PD Modification Application: MM 21-1090
Zoning Hearing Master Date: December 13, 2021
BOCC Land Use Meeting Date: February 8, 2022

AGENCY REVIEW COMMENT SHEET

2.5 Proposed Site Plan (partial provided below for size and orientation purposes. See Section 8.2 for full site plan)

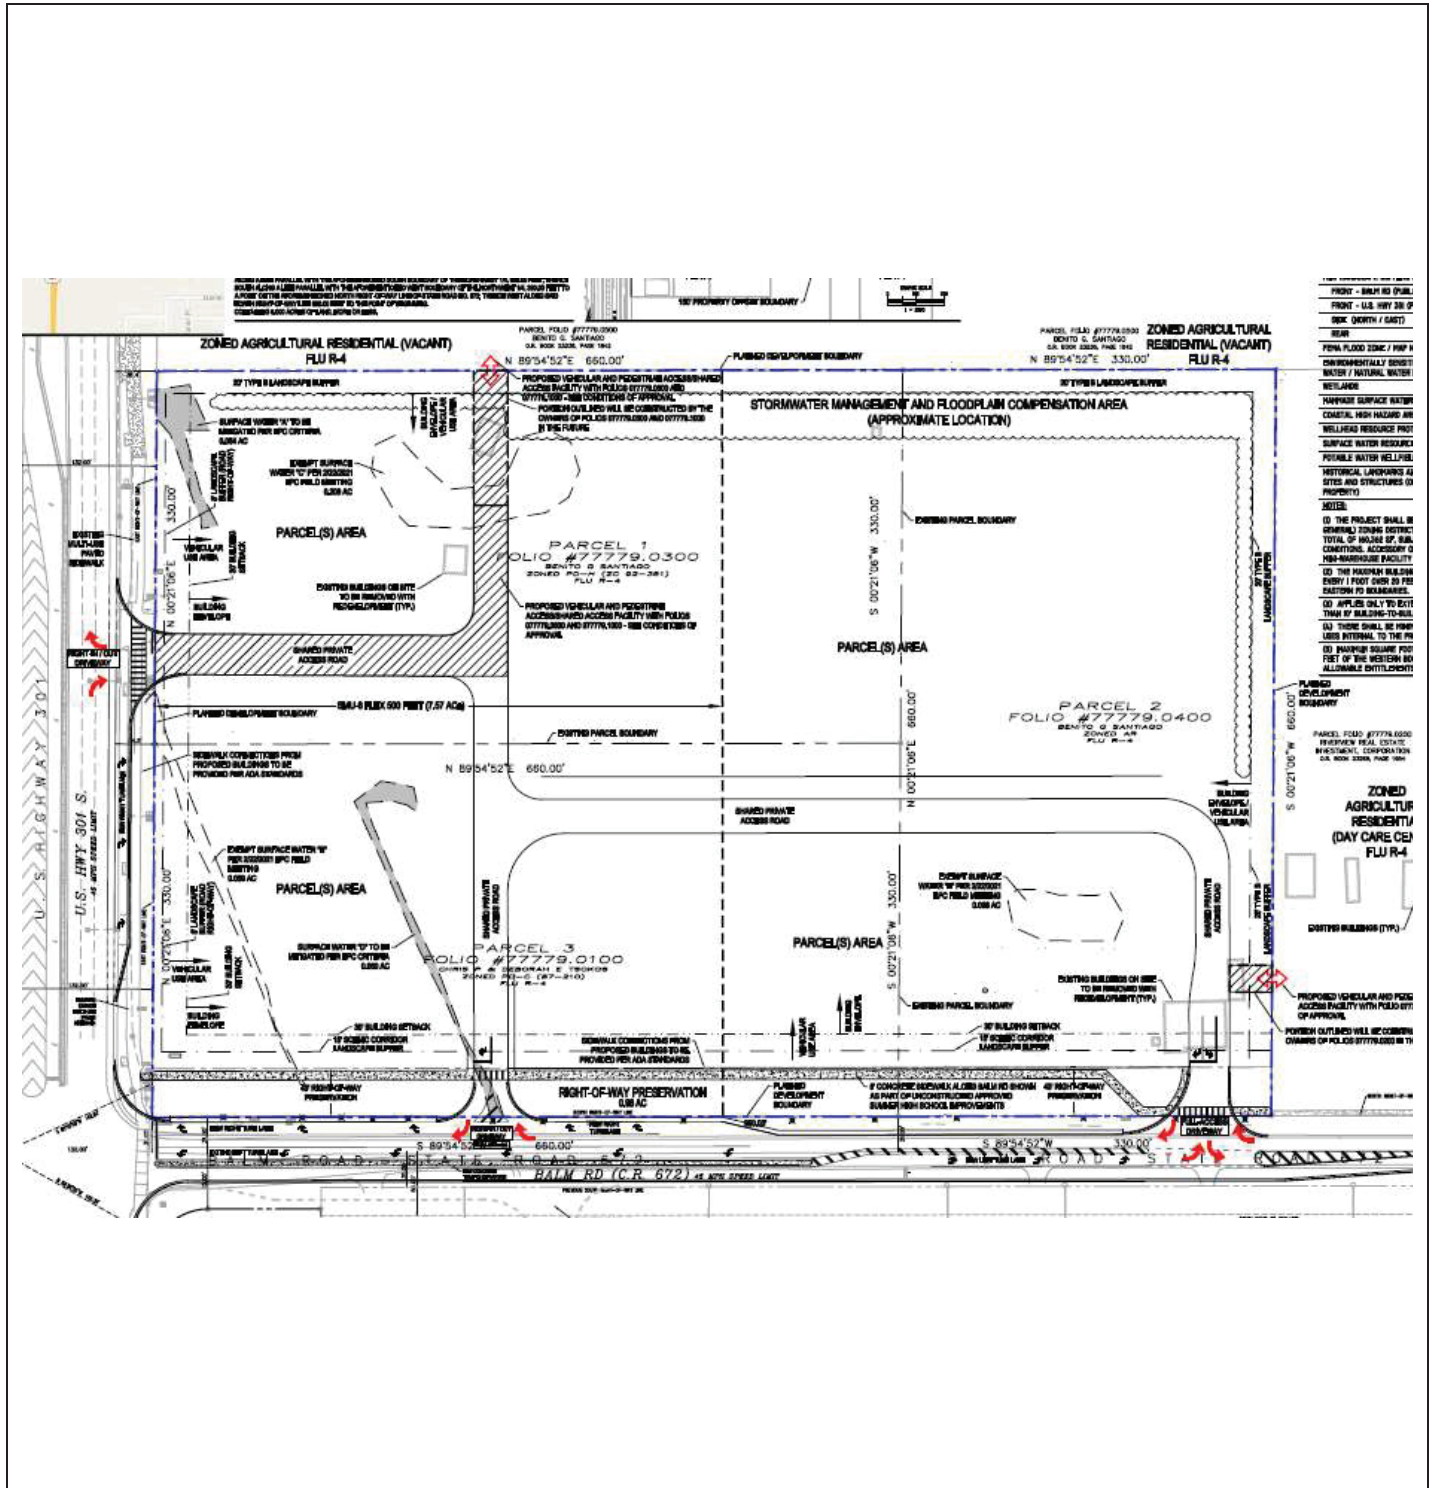
Existing Approval(s):	Proposed Modification(s):
150,000 square feet (0.22 FAR)	Increase the maximum square footage to 160,362 square feet (0.25 FAR).
CG (Commercial General) zoning district uses with no maximums for any individual use	Maximum of 34,362 sf of CG zoning district uses and maximum of 126,000 sf for mini-warehouse use
No building design requirements for a mini-warehouse use	Building design requirements for a mini-warehouse use (see condition 1.1).

- 1.1 The mini-warehouse facility shall be comprised of one, multi-story primary mini-warehouse structure and multiple, single-story mini-warehouse structures that will screen the related open storage area. The primary mini-warehouse structure shall be architecturally finished to grade on all exterior building facades (north, south, east and west) together with architectural features, such as belt course, changes in material, fenestration, wall plane projections, overhangs and awnings, recesses, or other architectural finishes, that (a) provides a visual base at the ground floor of the structure, and (b) distinguishes the primary entrance into the structure. Parapets terminated with a cornice shall be required for all mini-warehouse facility structures using a flat roof, except for non-primary structure facades facing the open storage area. Non-primary single-story storage mini-warehouse structures shall be constructed using articulated vertical metal panels and have similar or compatible color and tones as the primary mini-warehouse structure on all exterior building facades (north, south, east and west).

2.5 Proposed Site Plan (partial provided below for size and orientation purposes. See Section 8.2 for full site plan)

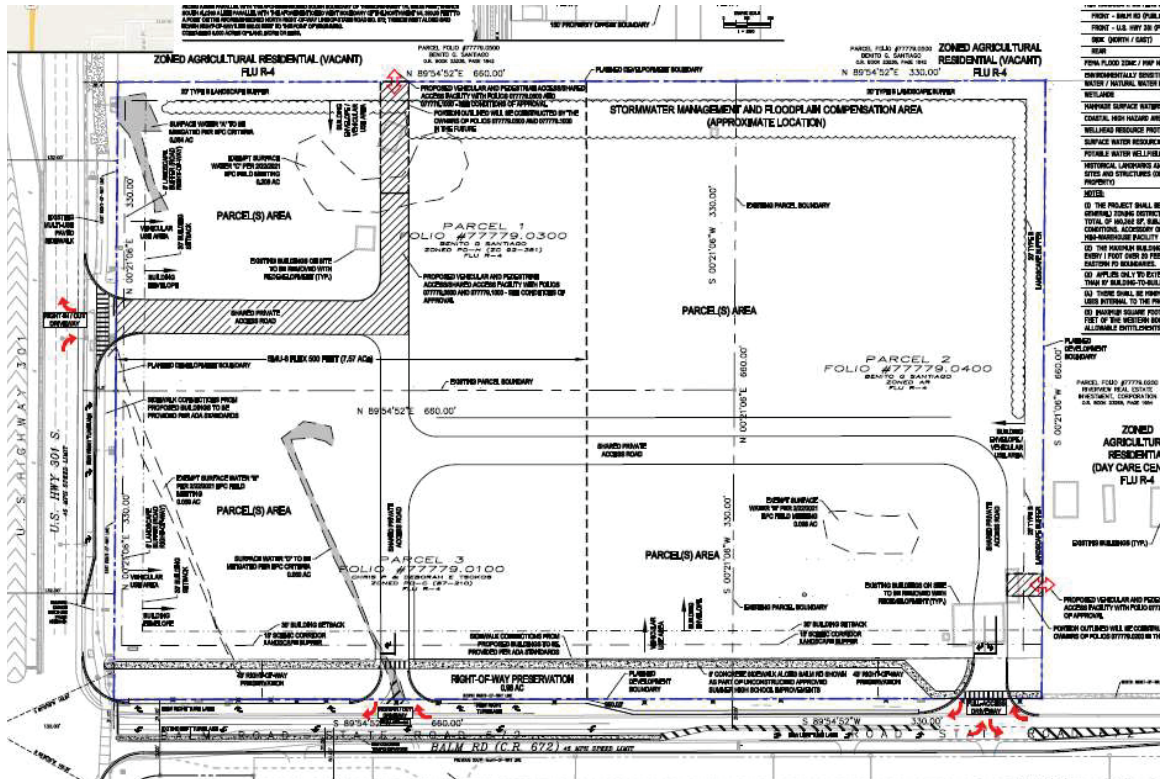
The Major Modification proposes to increase the maximum square footage from 150,000 square feet to 160,362 square feet (a maximum of 126,000 square feet for self-storage mini-warehouse and a maximum of 34,362 square feet for CG land uses).
